[Docket No. FAA-2015-3149; Directorate Identifier 2015-NM-014-AD; Amendment 39-18394; AD 2016-03-07]

Airworthiness Directives; Airbus Airplanes

ACTION: Final rule.

Figure 2 to paragraph (g) of this AD – Manufacturing (MFG.) date (05-02 = May 2002) example

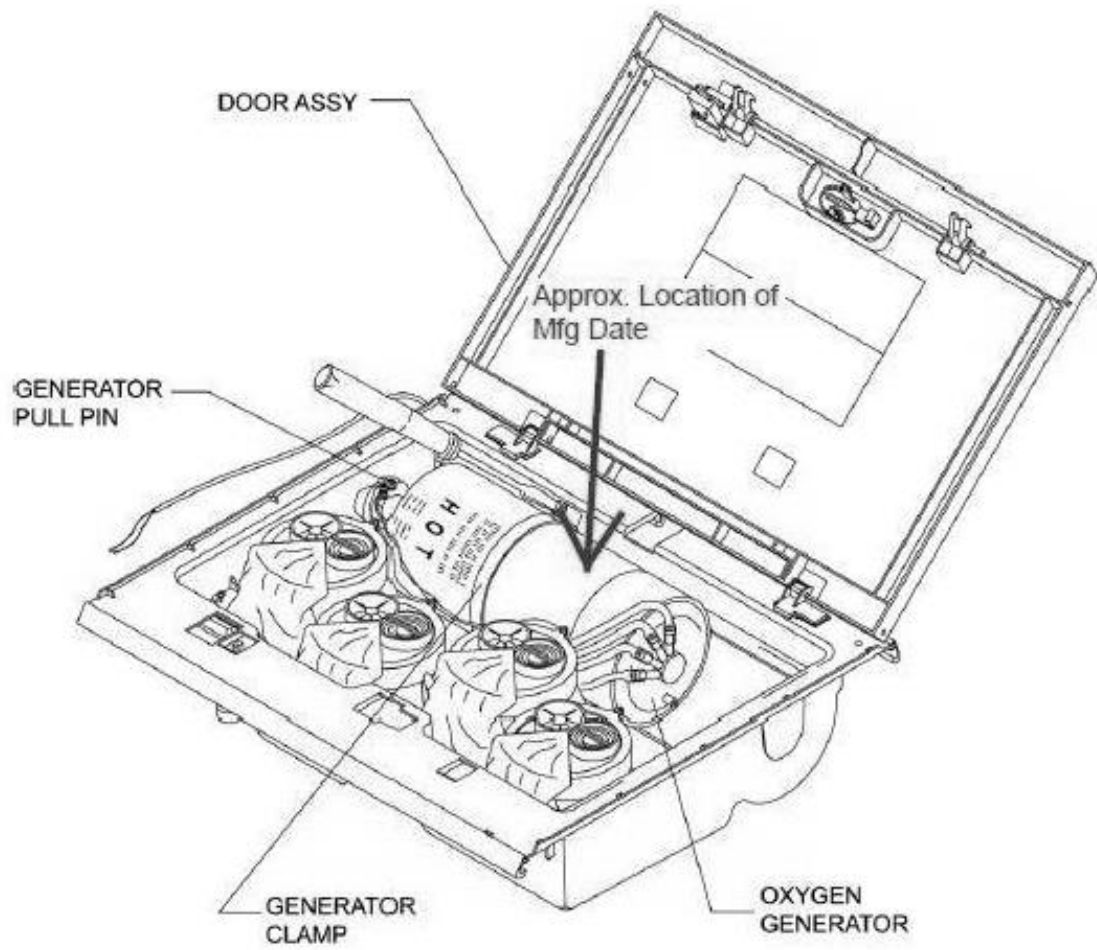
Airbus asked that we remove the operator identification from the chemical oxygen generator pictured in Figure 2 to paragraph (g) of the proposed AD (80 FR 52419, August 31, 2015). Airbus stated that Figure 2 to paragraph (g) should replicate

Figure 2 in EASA AD 2015-0119, dated June 24, 2015, which was published with no signs or references to an operator.

We agree with the commenter for the reason provided. We have changed the oxygen generator picture in Figure 2 to paragraph (g) of this AD accordingly.
